## PROPOSED PT20S BUILDING

2141 GIBSON BLVD SE  
ALBUQUERQUE, NM  
87106

## SITE DIMENSION PLAN

C-3.0

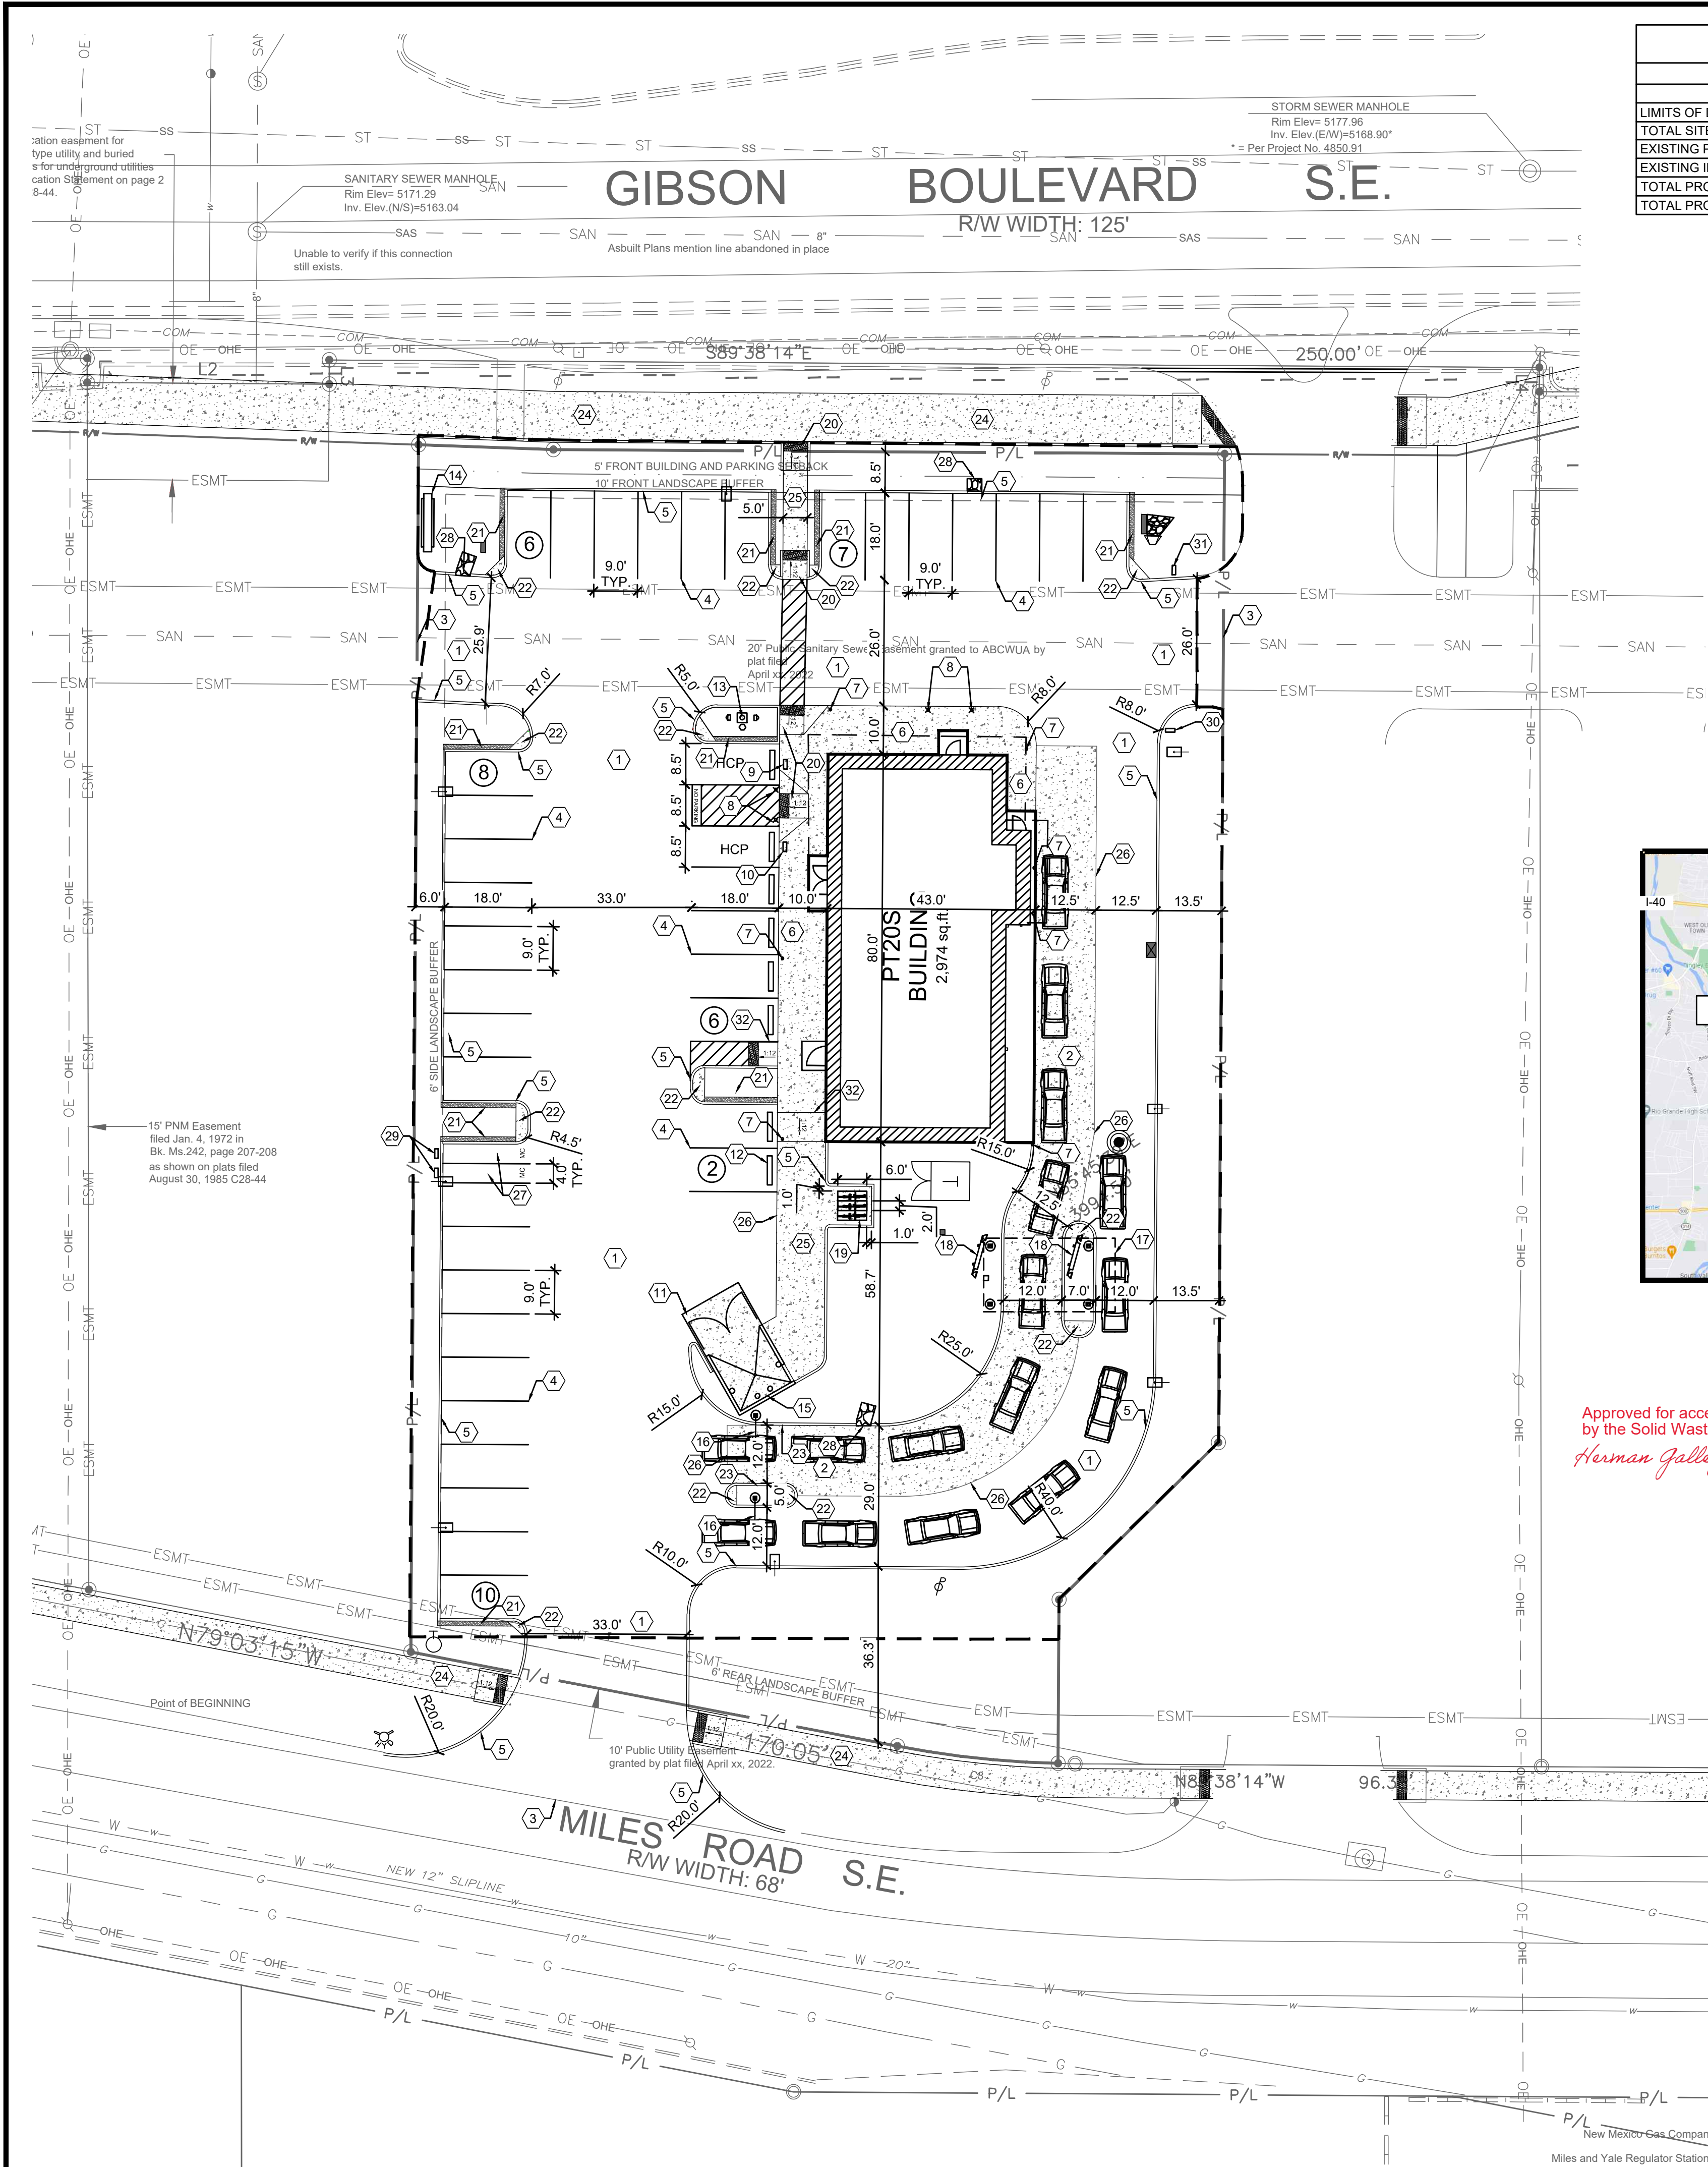
Approved for access for 1 VIP Compactor enclosure  
by the Solid Waste Department Herman Gallegos 09-29-22  
*Herman Gallegos*
